APPLICATION NO.	FILING DATE	FIRST NAMED INVENTOR	ATTORNEY DOCKET NO.	CONFIRMATION NO.
10/780,378	02/17/2004	Jeff Blaylock	ZIM0356	1826
7590 12/12/2007				
John F. Hoffman, Esq. BAKER & DANIELS LLP Suite 800 111 East Wayne Street Fort Wayne, IN 46802				
			EXAMINER PREBILIC, PAUL B	
			ART UNIT 3774	PAPER NUMBER
			MAIL DATE 12/12/2007	DELIVERY MODE PAPER

Office Action Summary	Application No. 10/780,378	Applicant(s) BLAYLOCK ET AL.	
	Examiner Paul B. Prebilic	Art Unit 3774

DETAILED ACTION

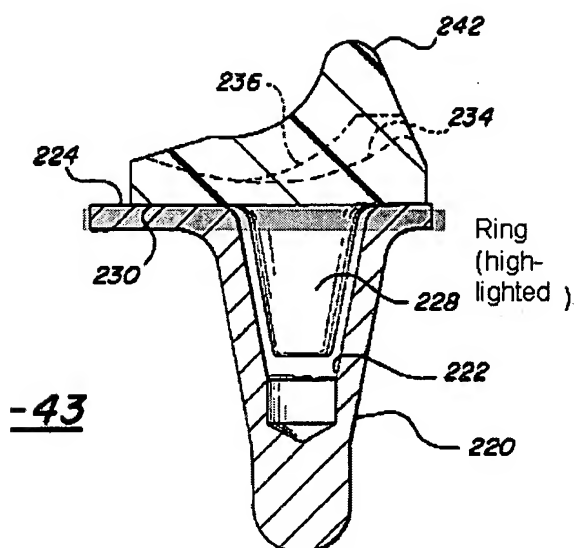
Claims 56, 58-60, and 62-66 are rejected under 35 U.S.C. 102(b) as being anticipated by Pottenger et al (US 6,039,764). Pottenger anticipates the claim language where the tibial implant as claimed corresponds to the bearing element (226) of Pottenger, the tibial augment as claimed corresponds to the tibial component (218), the ring-shaped annular body as claimed corresponds to the highlighted portion of the tibial component that surrounds the recess (222) (see illustration below); and the passageway as claimed is the recess (222); see Figure 43 and column 23, lines 21-39.

With regard to claim 62, the claim language is met where the heights can be measured along the angled portions and compared to the heights of the vertical portions.

With regard to claim 64, the exterior wall as claimed is the underside of the plate of Pottenger.
